Please find below the response to the review formulated for the CDM project "Tangshan Jidong Cement Matoushan Matishan 25MW Cement Waste heat Recovery Project" with the registration number 2587. In case you have any further inquiries please let us know as we kindly assist you.

Response to the CDM Executive Board

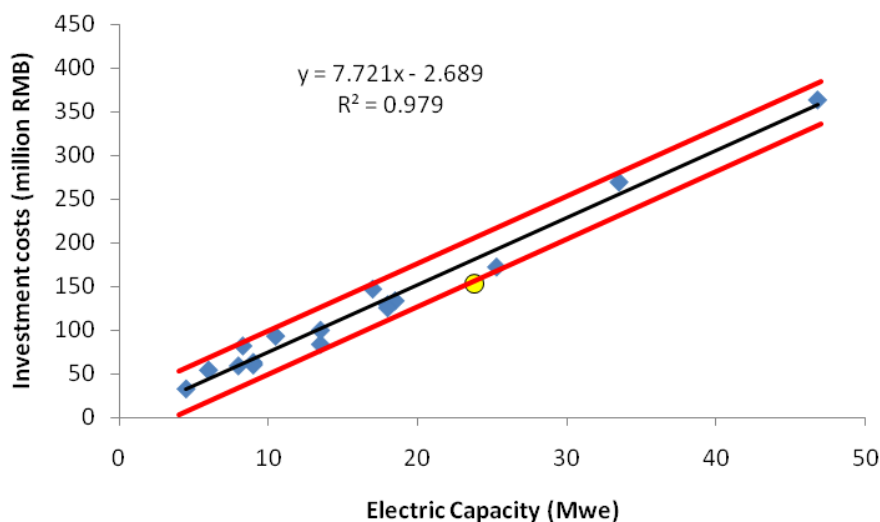
2. The DOE shall further substantiate: (i) the suitability of the input values to the investment analysis in line with the paragraph 111 (c) of VVM, in particular, total investment, annual O&M cost, and annual operational hours; and (ii) why demand/capacity charge, if it would have been paid in the absence of the project activity by the project participant, has not been considered as savings in the investment analysis.

Additional to above, we have compared the investment cost of the proposed project in the FSR (i.e. 153,225,800 RMB) to similar registered projects listed in Annex 1. The projects are plotted in a scatter graph with their Investment costs in million RMB on the (y)-axis and the installed electric capacity in MWe on the (x)-axis. These projects are the basis of the regression analysis. The investment costs were predicted based on the average mean of the Investment cost per total installed capacity and the standard deviation. The regression formula has been defined as:

$$\text{Inv (million RMB)} = 7.721 \text{ Cap (MWe)} - 2.689$$

The figure below depicts a regression analysis assuming a linear relationship between the investment costs in RMB and installed capacity in MW for similar cement WHR projects. The proposed project activity (yellow dot) is around -2 standard errors (indicated in red line) removed from the black trend line, which means that the estimated Investment cost of the project activity is smaller than the investment cost of similar projects. Hence, we can conclude our “crosscheck” in accordance paragraph 111(c) of the VVM, concludes that an IRR calculation based on the Investment costs of the FSR which we have conducted is conservative as low investment cost will result in an overestimation of the IRR.
